SERVICE DIRECTIVE BULLETIN NO. 0051

Subject: Main Rotor Transmission Mounting Hardware

Models: All

FIGURE 1

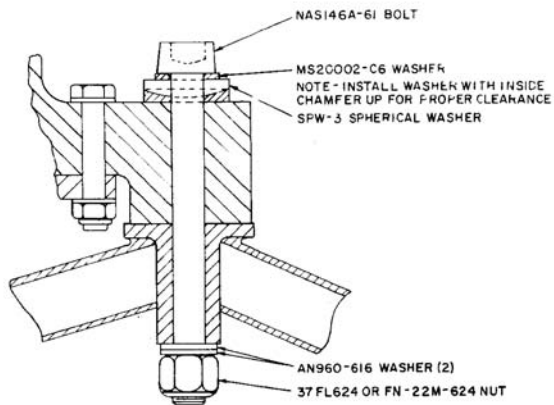
1. Main rotor transmission S/N 42-006-76PS and below, which have not been previously machine spot faced on the upper side of the mounting pad, as shown in fig. 2, have previously been retrofitted with bolts and hardware installed as called for in Service Information Letter No. 0057. The Service Information Letter No. 0057 configuration is to be modified by removing the cotter pin and nut (P/N AN 310-6) from each mounting bolt and replacing with either nut P/N 37 FL 624 or FN-22M-624. Refer to figure 1.

FIGURE 2A

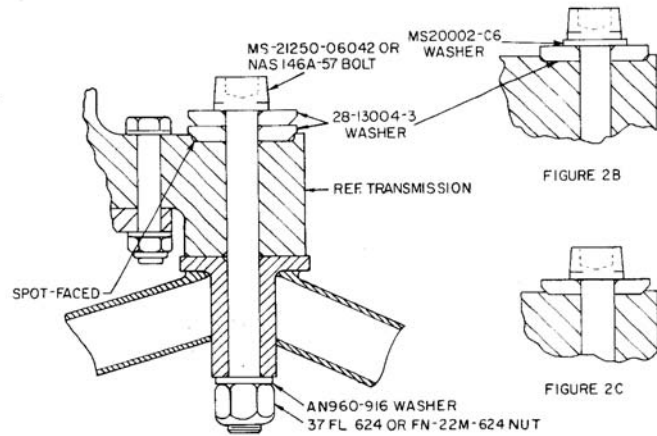
2. Main rotor transmission S/N 42-007-76PS through S/N 46-182-79C, have spot faced mounting pads. These transmissions may require a variety of washers as the dimension of the mounting pad thickness may vary. Acceptable bolt installation and spacing is shown in figure 2, parts A, B, and C. Because of the potential interference of a pylon tube, the left aft mounting bolt may require shimming under the bolt head and chamfered washer.

NOTE: Care must be taken that only a chamfered washer be placed under the head of the bolt and required shims of “AN” washers to complete spacing be placed between the chamfered washer and the transmission lug. The part number for these washers are also called out in figure A and B.

FIGURE 3

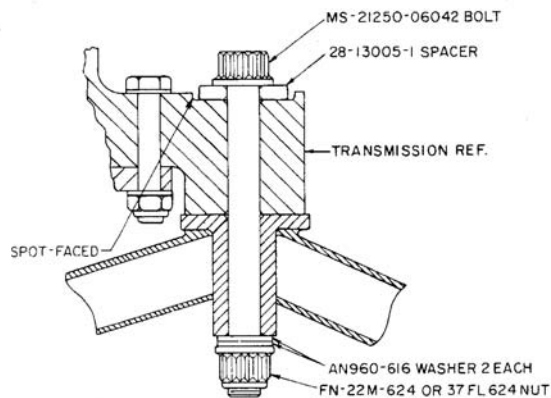
3. Main rotor transmissions S/N 46-182-79C and up, have spot faced mounting pads of a controlled dimension and mounting bolts have been installed per figure 3. No change is required. This configuration of bolt and nut is satisfactory for all prior transmission serial numbers provided that the self aligning washer configuration of Service Information Letter 0057 is used with non-spot faced transmission mount as shown in figure 1 and the proper spacing of figure 2 is maintained with spot faced transmission mounts.
